SUBJECT: Site Closure for Perrenoud, Inc. Located at 420 W. Wisconsin Street in Chippewa Falls, WI

WD CASE SUMMARY AND CLOSE-OUT FORM

SITE NAME Perrenoud, Inc

SUBJECT: Review of the Phase II Remedial Investigation Work Plan for the Perrenoud, Inc. site located at 420 West Wisconsin Street, Chippewa Falls, WI

| REVISED BY/DATE | SITE FEATURES MAP | FIGURE 2 |

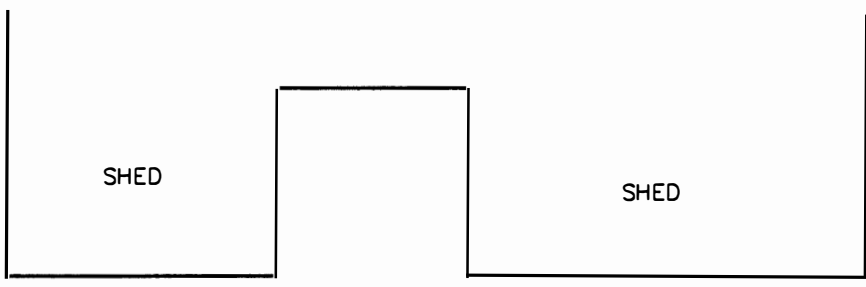
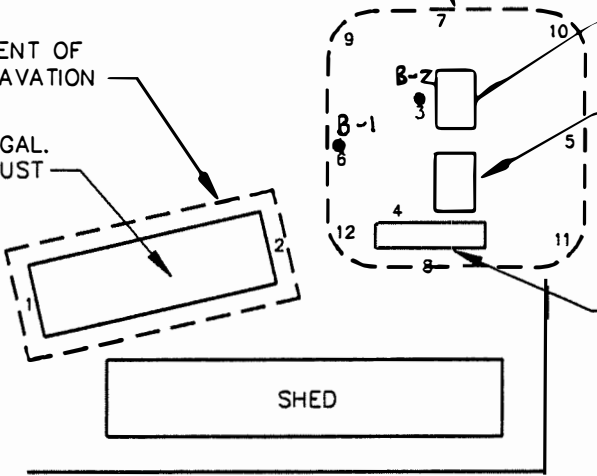
[Handwritten note: 2 borings below exc level sample locations 3 and 6]

| ACTION (code from above) | DATE (mm/dd/yy) | COMMENT |
|--------------------------|-----------------|---|
| <u>99</u> | <u>7/2/92</u> | <u>Close-out denied. 3ASTs; 427 yd. to fence; 15TPH on sidewalk after excavation; no mid-excavation sampling. Needs borings at base of tank bed + sampling.</u> |

| Boring Number | Locations | Total Depth |
|---------------|--|-------------|
| B-1 | West Wall of Excavation - Sample No. 6 | 21 feet |
| B-2 | Base of Diesel UST Excavation - Sample No. 3 | 21 feet |

The exact locations of borings are presented on the attached Figure 2.
